**ADDENDUM NO. 01**

**TO: PLANS AND SPECIFICATIONS FOR STATE OF MISSOURI**

**Replace Fire & Smoke Detector System  
Harry S. Truman State Office Building  
Jefferson City, Missouri  
PROJECT NO. O2001-01**

**1 LEVEL 1 ENLARGED FIRE ALARM PLAN - NEW WORK (CAPITOL POLICE)**  
SCALE: 1/2" = 1'-0"

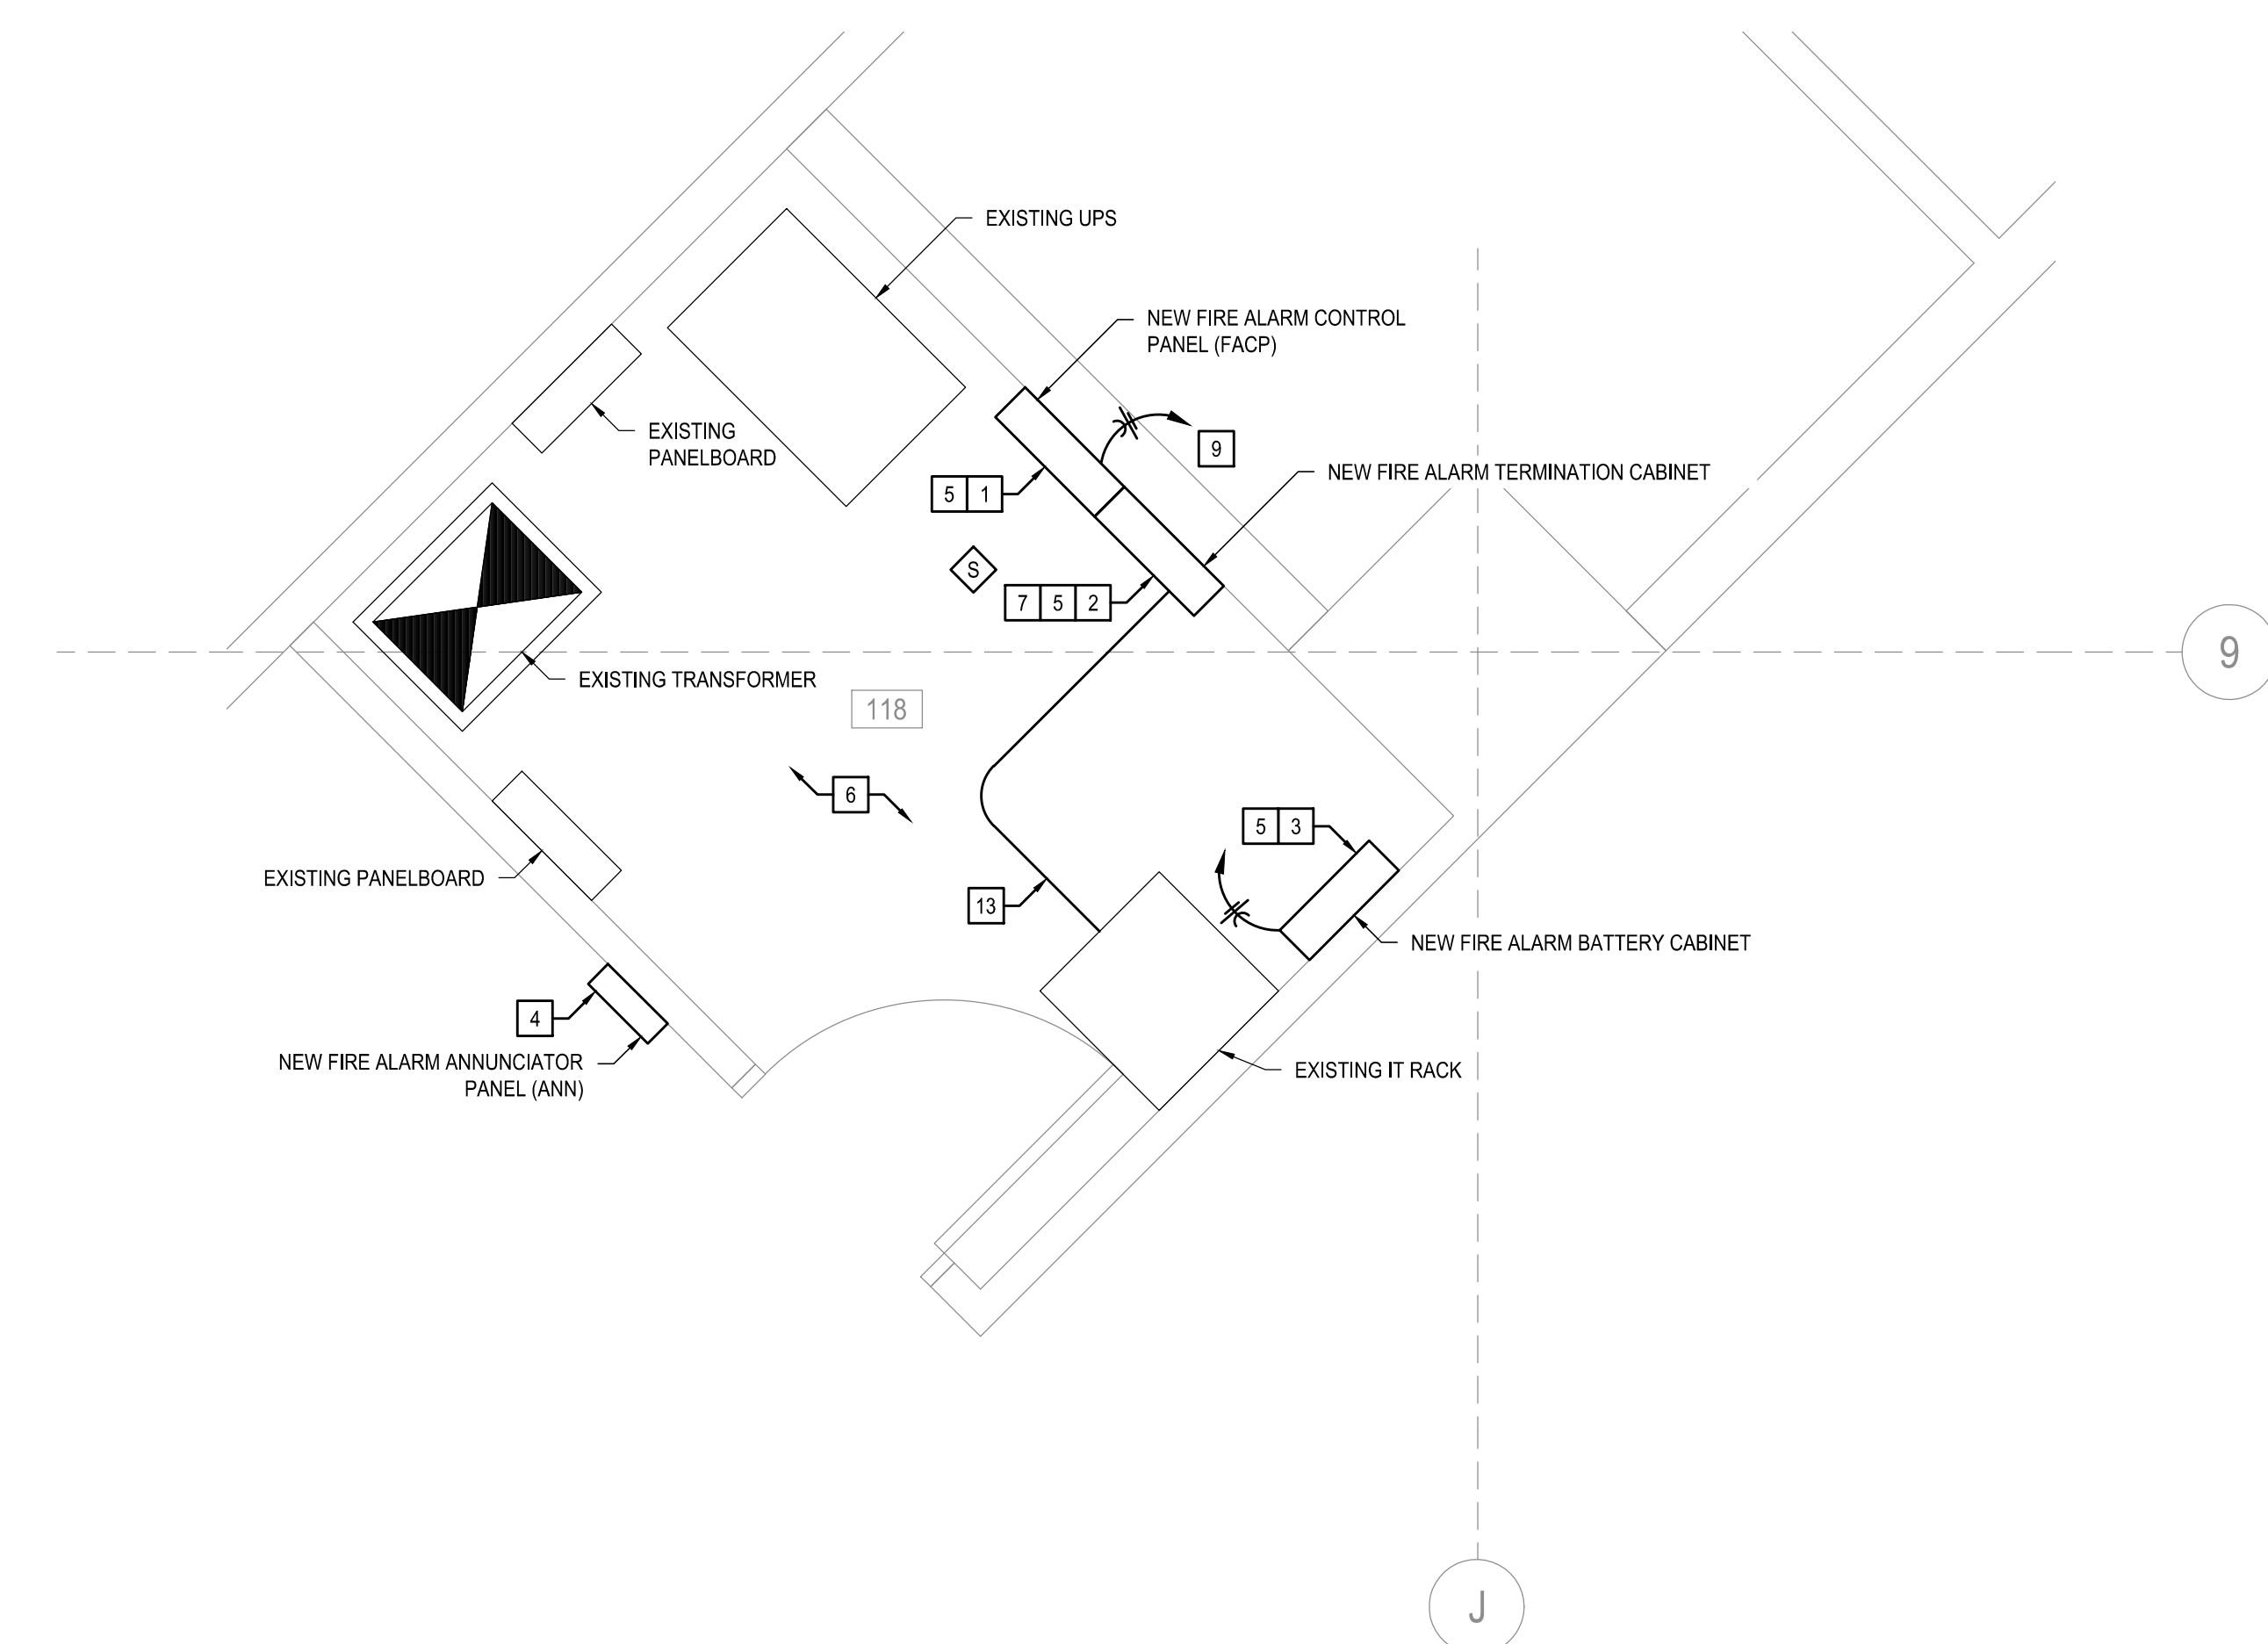
1. Drawing FA401:
  - a. **ADD** information for Building Announcement panel.

- PROVIDE NEW 16" X 16" HINGED, LOCKABLE, NEMA 1, FLUSH MOUNTED ENCLOSURE FOR BUILDING ANNOUNCEMENT CONTROLS. PROVIDE WITH CLEAR HINGED COVER. PROVIDE DOOR-IN-DOOR PANEL WHERE POSSIBLE. REFER TO FA003 FOR ADDITIONAL INFORMATION.

**8 BUILDING ANNOUNCEMENT CONTROL PANEL "BACP-01"**  
SCALE: N.T.S.

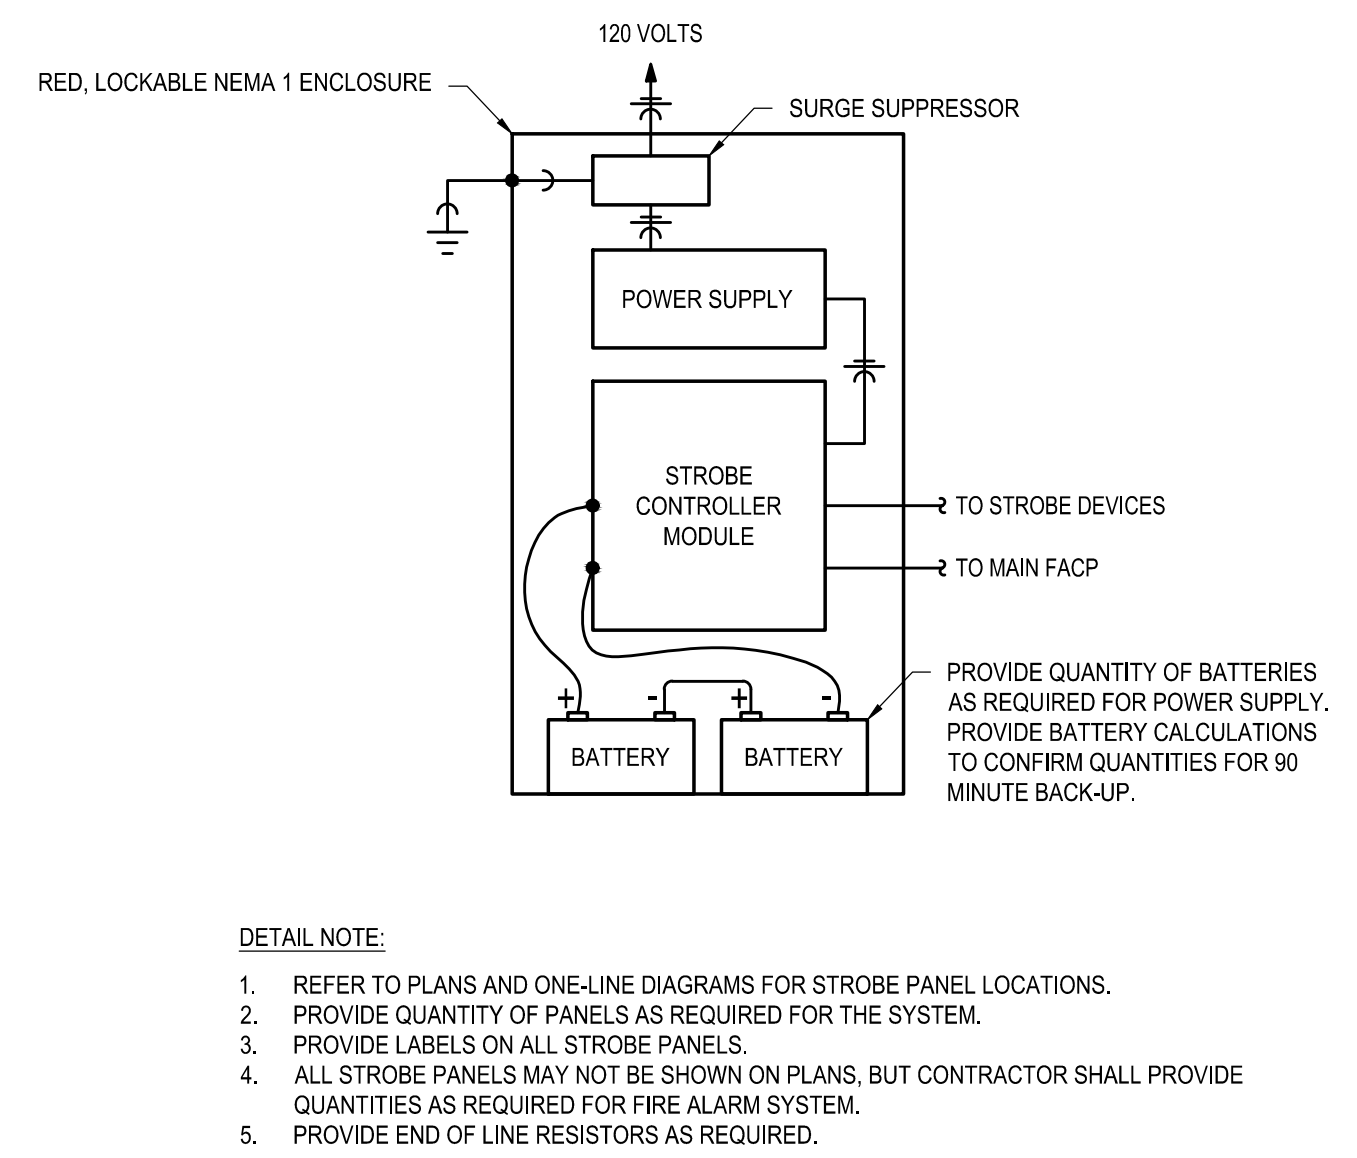
2. Drawing FA503:
  - a. **ADD** detail for building announcement panel “BACP-01”.

**1 BEAM SMOKE DETECTION WIRING DETAIL**  
SCALE: N.T.S.

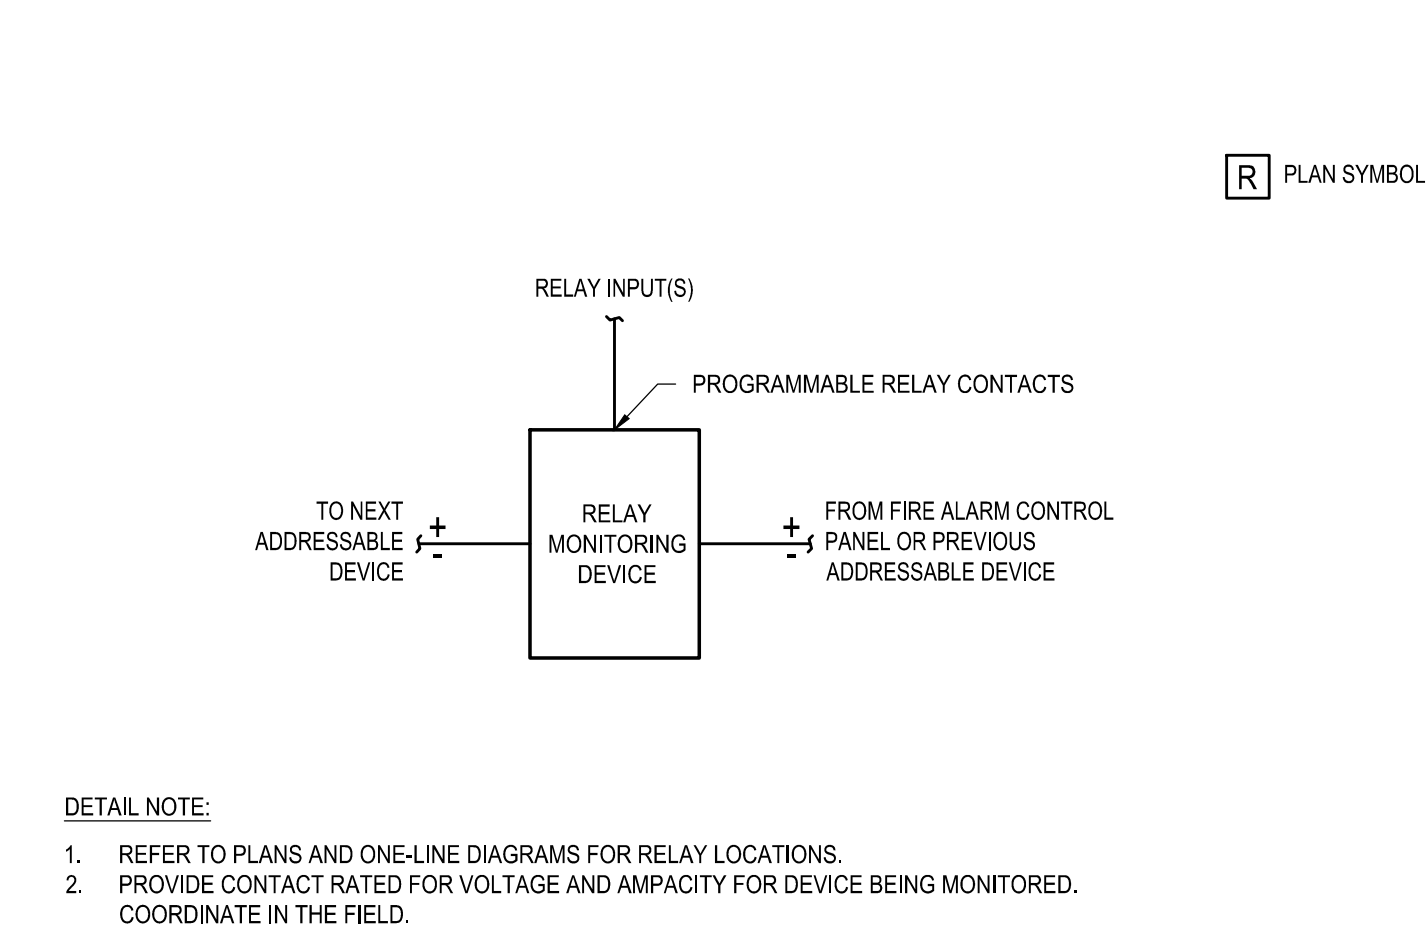
Q13. The spec and the drawing detail are contradictory. The spec references the use of an addressable beam detector due to sections 2.10.B.2.b and 2.10.B.2.i. The drawing detail on sheet FA503 supports the use of 4 wire beam detectors monitored by modules for status.

Q14. Is it acceptable to use 4 wire conventional beam detectors monitored with modules? This would reduce the cost of the project. Sections 2.10.B.2.b and 2.10.B.2.i would need to be removed to allow this. Is that acceptable?

**A13. This has been clarified above. The devices will not need to be addressable.**

**A14. Yes. This has been clarified above.**

**1 PARTIAL FIRE ALARM RISER DIAGRAM - SOUTH LEVELS 1 - 4**  
SCALE: N.T.S

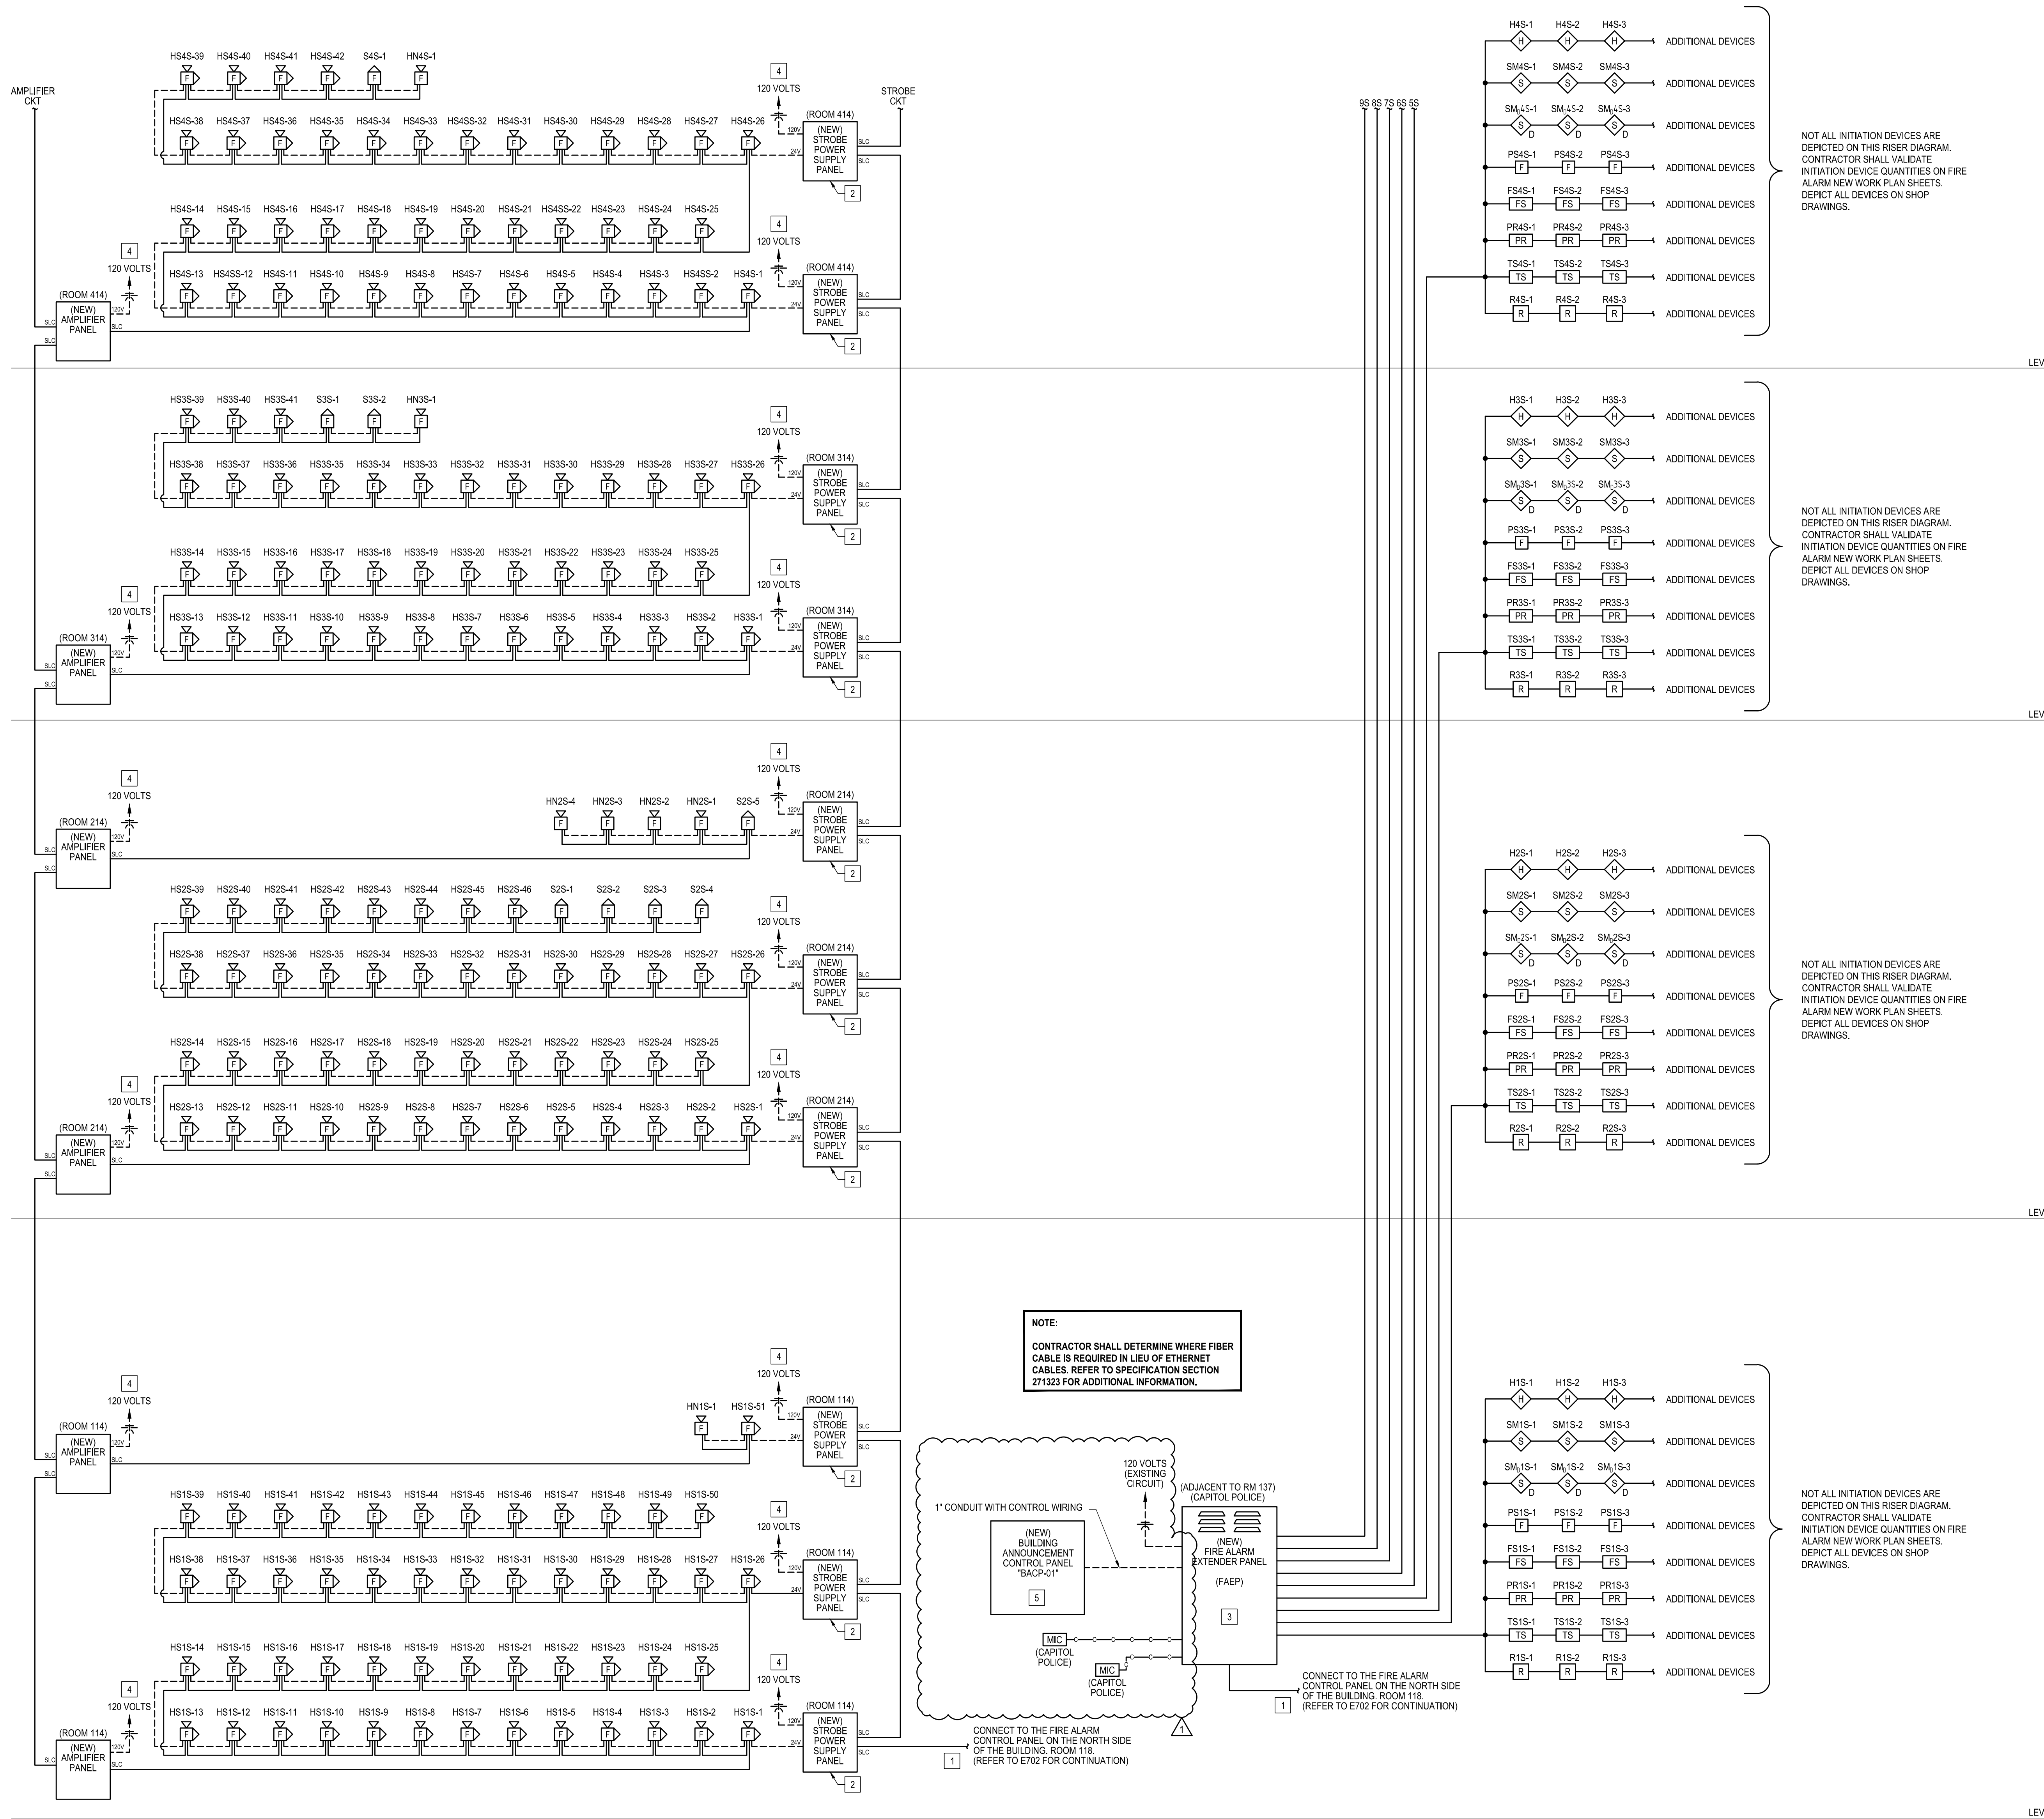
3. Drawing FA704:
  - a. **ADD** announcement panel to the fire alarm riser diagram.
